Front Bumper Face Pulls Loose

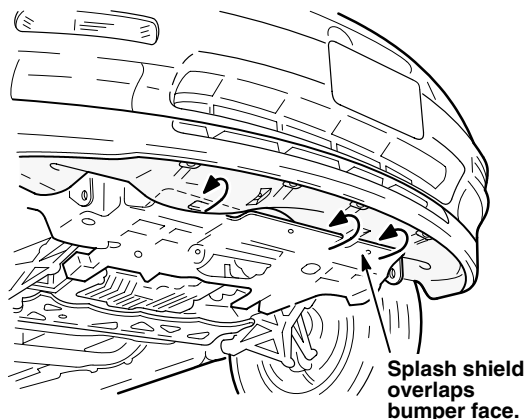
1. Raise the vehicle on a hoist.
2. Remove the two lower bumper face plastic mounting fasteners.
3. Remove the three 6 mm bolts that mount the front of the splash shield to the subframe (visible through the square holes in the lower bumper face).

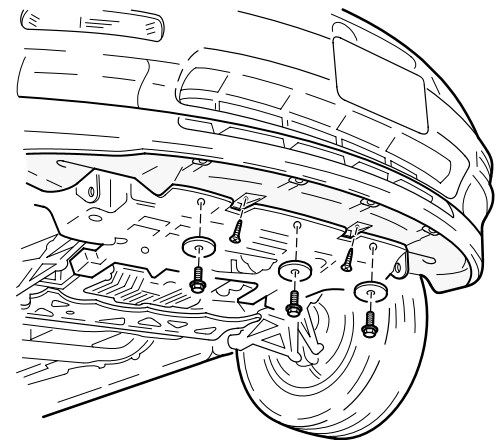
4. Pull out the front edge of the splash shield, and place it on top of the lower bumper face.

5. Reinstall the two plastic fasteners in the lower bumper face. Replace them if they are damaged (see PARTS INFORMATION).
6. Reinstall the three 6 mm bolts, using a large washer on each bolt to reinforce the mounting point (see PARTS INFORMATION).
